Product Change Notification / ALAN-18KFQO196

CCB 6017 Initial Notice: Qualification of MMT as an additional assembly site for selected AT24Cxx device family available in 8L TSSOP (4.4mm) package.

PCN# ALAN-18KFQO196

Pre and Post Change Summary

ANAP

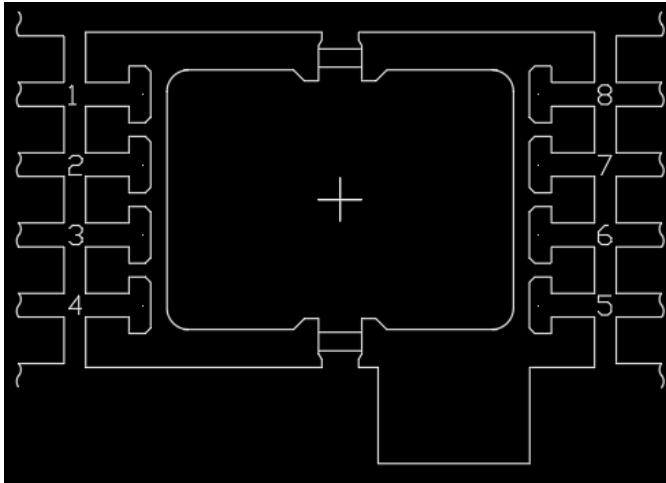
Bond Wire Material	PdCu
Die Attach material	8290
Mold compound material	G700A
Lead-Frame Paddle Size	98 x 87 mils

ASSH

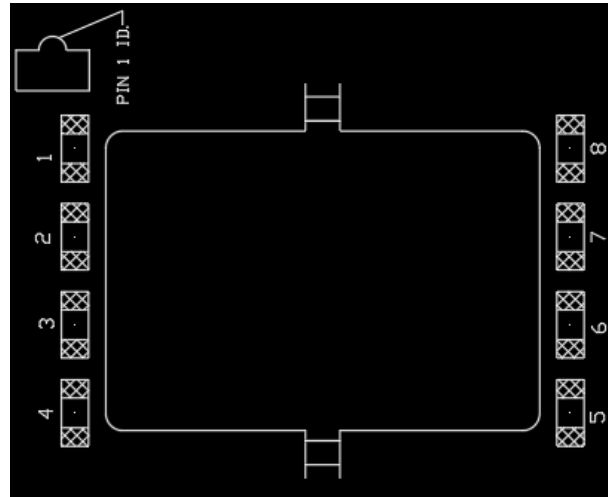
Bond Wire Material	PdCu
Die Attach material	EN-4900G
Mold compound material	G700LY
Lead-Frame Paddle Size	126 x 87 mils

MMT

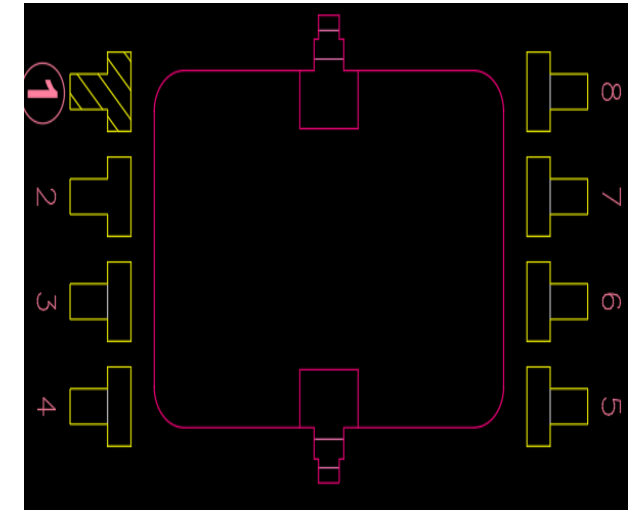
Bond Wire Material	Au
Die Attach material	2200D
Mold compound material	G600V
Lead-Frame Paddle Size	118 x 87 mils
